PARTS & SERVICE NEWS

REF NO.	AT02086
DATE	Jul. 18, 2002

SUBJECT: REPAIR PROCEDURE OF AIR CONDITIONER COMPRESSOR ADJUSTMENT ROD & PULLEY COVER ON HM300-1

PURPOSE: To introduce modification procedure to prevent occurrence of cracks in the drive belt adjusting rod and in the air compressor pulley cover on HM300-1 articulated dump trucks

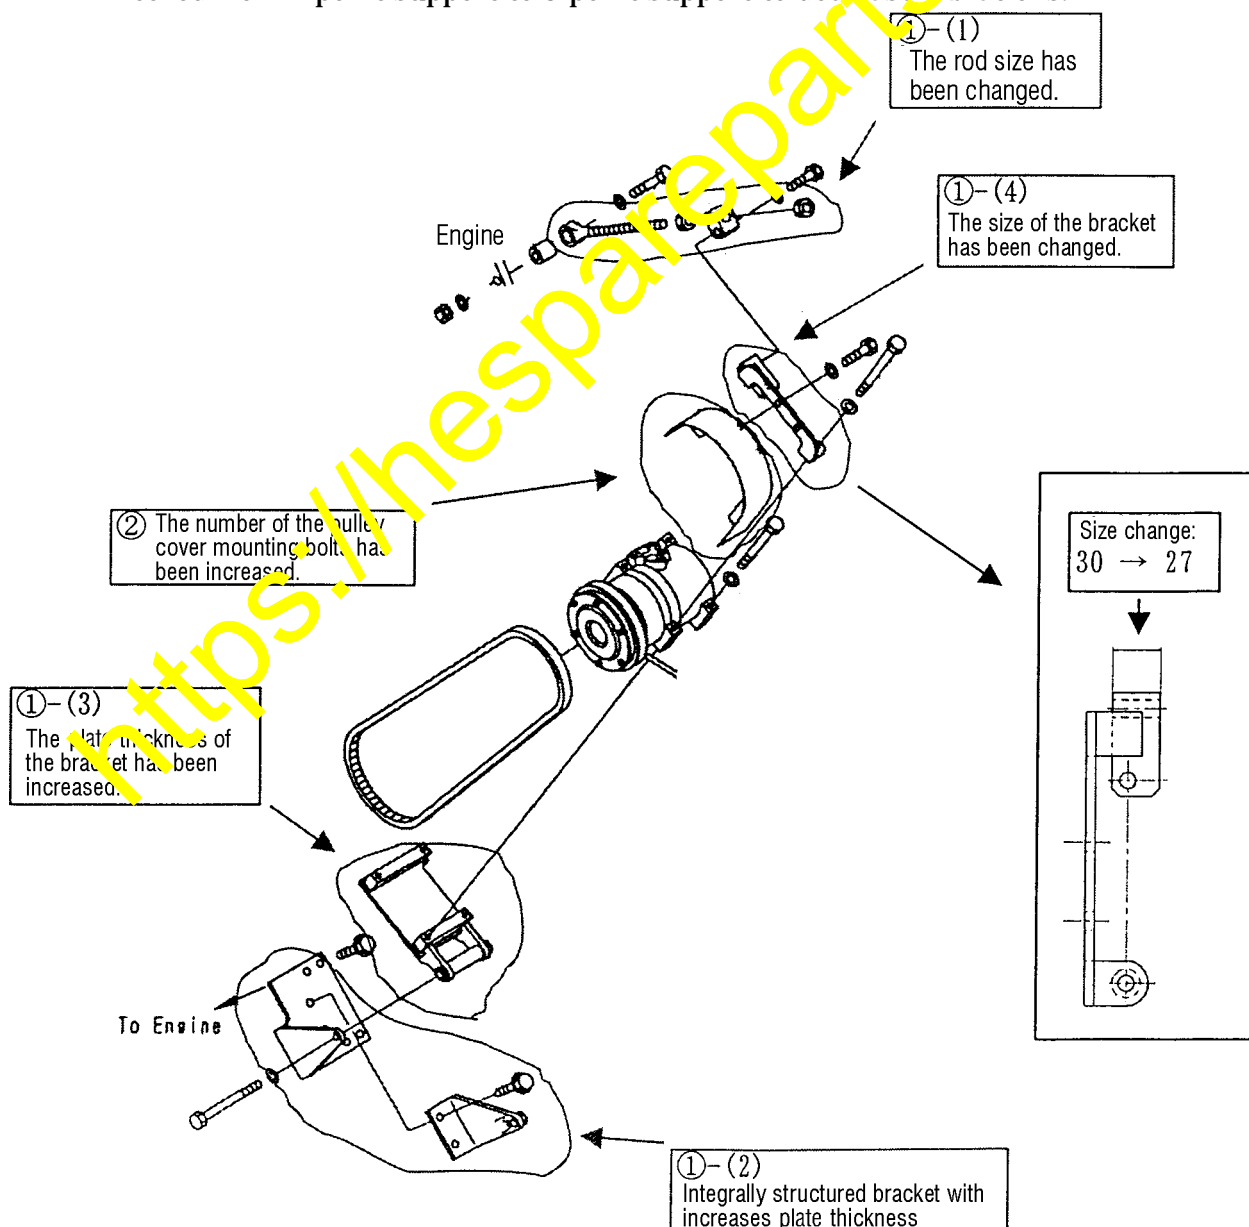
① Modification of the tension rod for the air compressor

(1) Reinforcement of the tension rod

The thread size of the tension rod has been changed from M14 to M16.

(2) Reinforcement and improvement of the accuracy of the air compressor mounting frame bracket.

The current air compressor mounting frame bracket of a two-part bolt-on structure with the sheet thickness of t 8 has been changed to a welded integrally structured bracket with the sheet thickness of t 12.

(3) Reinforcement of the hinge bracket

The plate thickness of the hinge section of the hinge bracket has been changed from t 9 to t 12.

(4) Changing the rod mounting position

To match the rod mounting surface on the engine side and the same on the air compressor side, the size of the bracket has been changed.

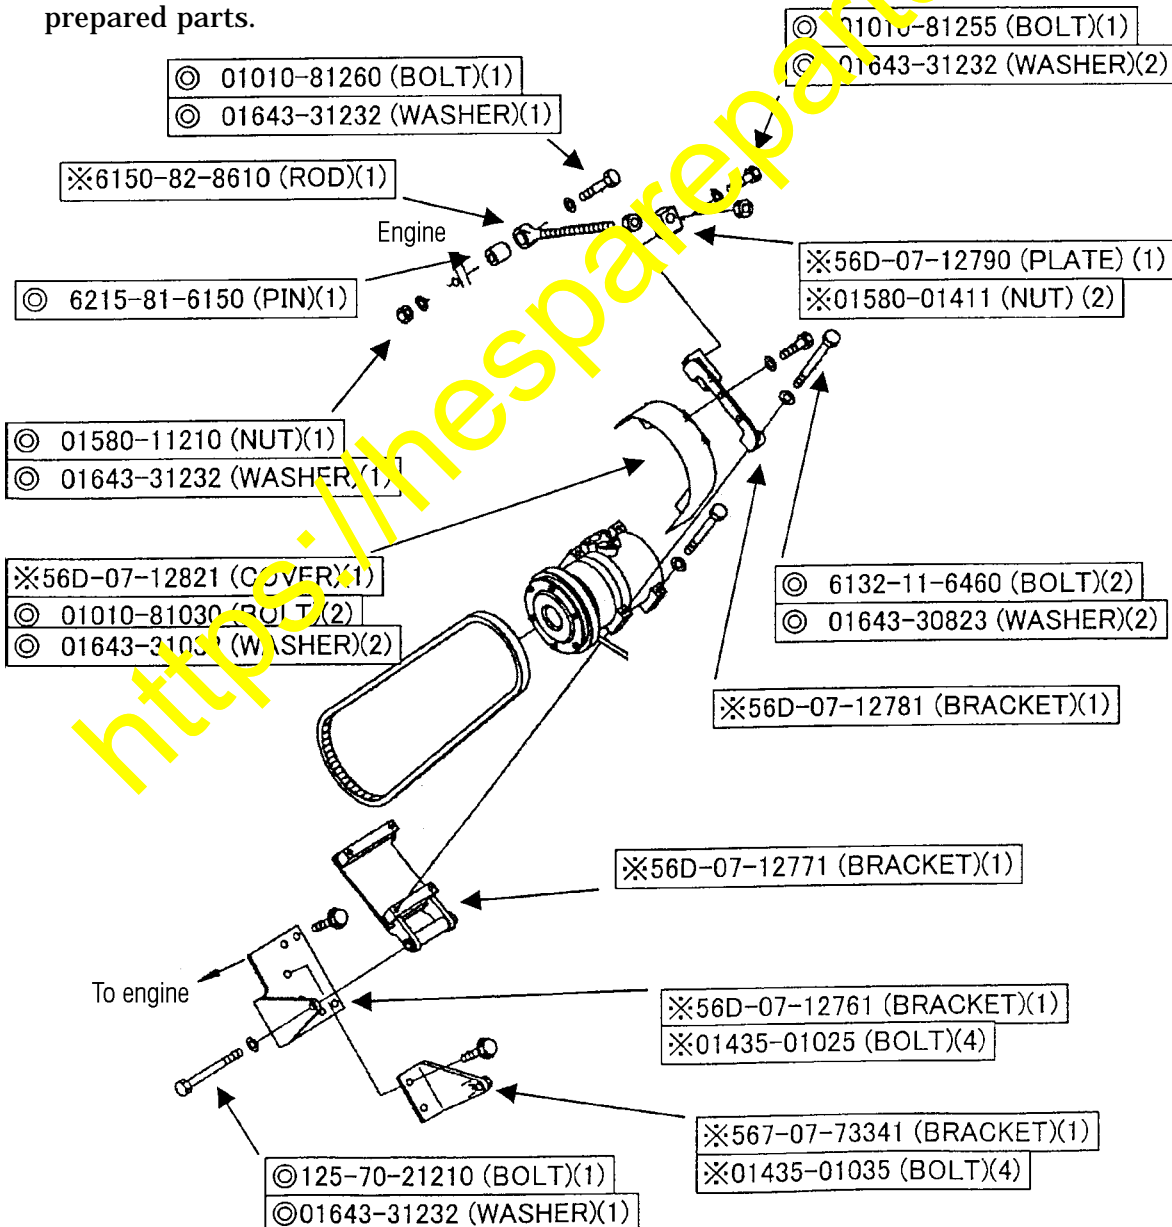
Remove the parts marked ⊙ and ※ in the figure below.

Since the parts marked ⊙ are being reused when installing the improved parts, be careful not to lose them nor damage them.

Parts marked ※ are to be replaced with the newly prepared parts.

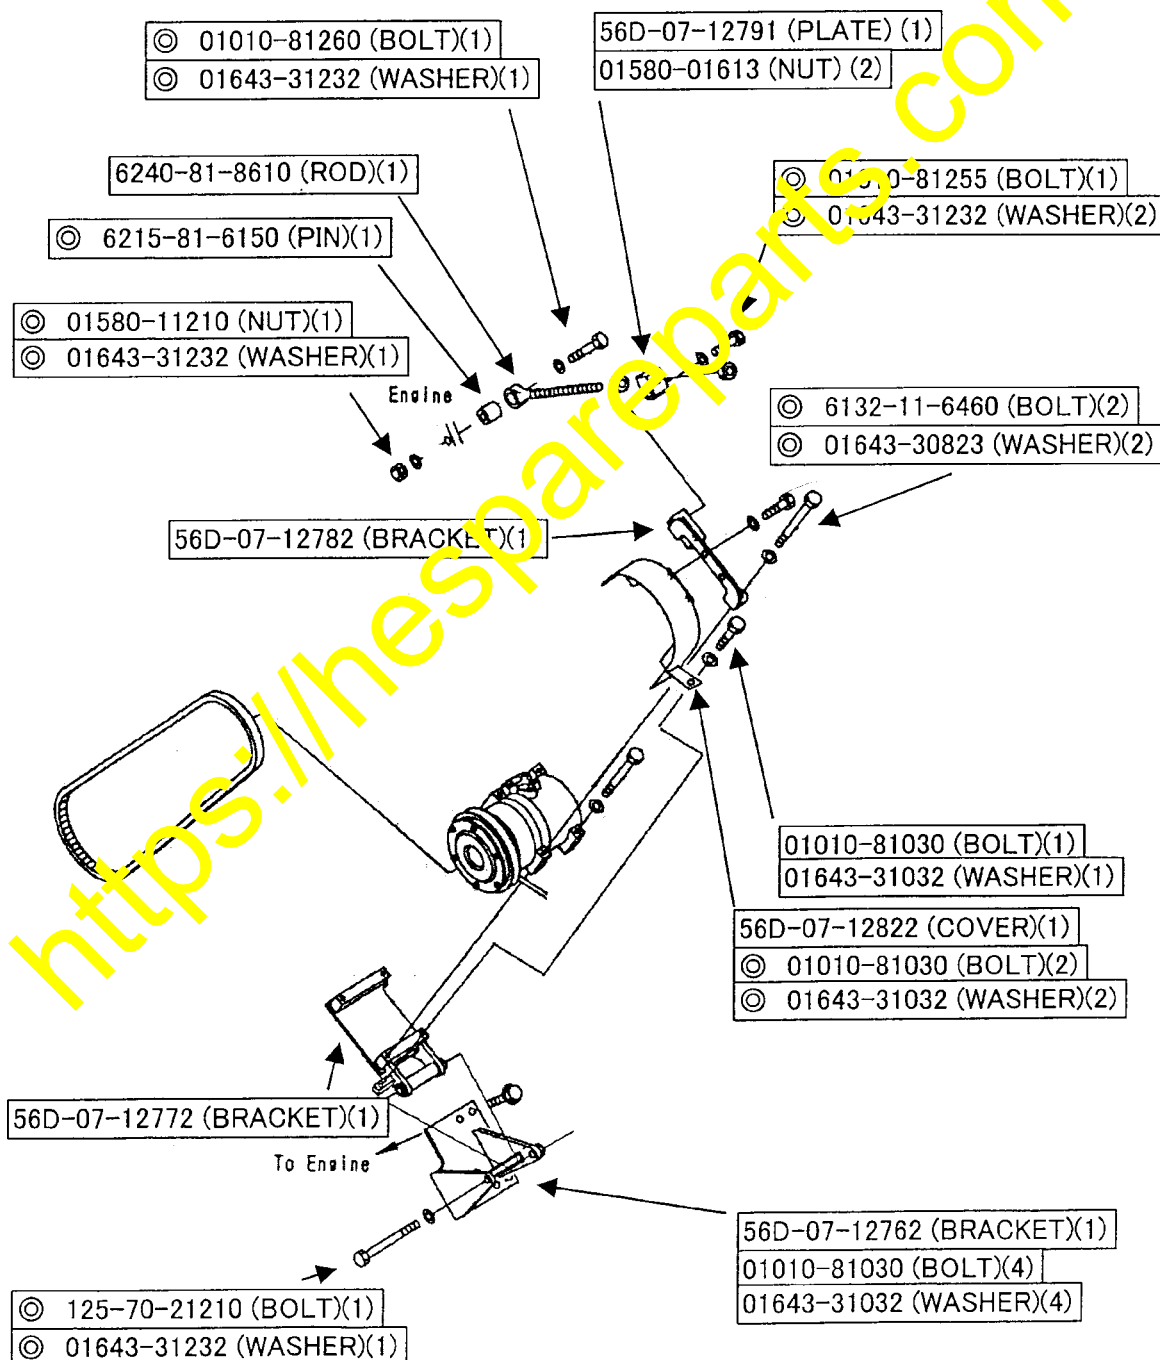
Install the parts following the procedure being described below. (Refer to Fig. 2.)

- 1) Install the bracket (56D-07-12762) to the engine.
- 2) Install the bracket (56D-07-12772). Lightly screw-in the mounting bolts (125-70-21210).
- 3) Install the air compressor to the bracket (56D-07-12772).
At this time, install the bracket (56D-07-12782) together using the same mounting bolts.
- 4) Install the rod (6240-81-8610) and plate (56D-07-12791).
At this time, lightly screw-in the mounting bolts (01010-81255).

Note: Although some vehicles are being equipped with the rod and plate of the new part numbers, replace these rod and plate to new parts also.

- 5) Setting the drive belt over the air compressor pulley, adjust the nut (01580-01613) to tighten the belt tension.
(Tighten the belt tension so that the belt will be bent by about 10 mm when the center point of the belt is pressed by a thumb (58.8N{6kgf}).)

- 6) After finishing the belt tension adjustment work, tighten the bolts (125-70-21210) and (01010-81255).
Tightening torque: 98 – 123 N·m {10.0 – 12.5 kgf·m}
- 7) Install the pulley cover (56D-07-12822).
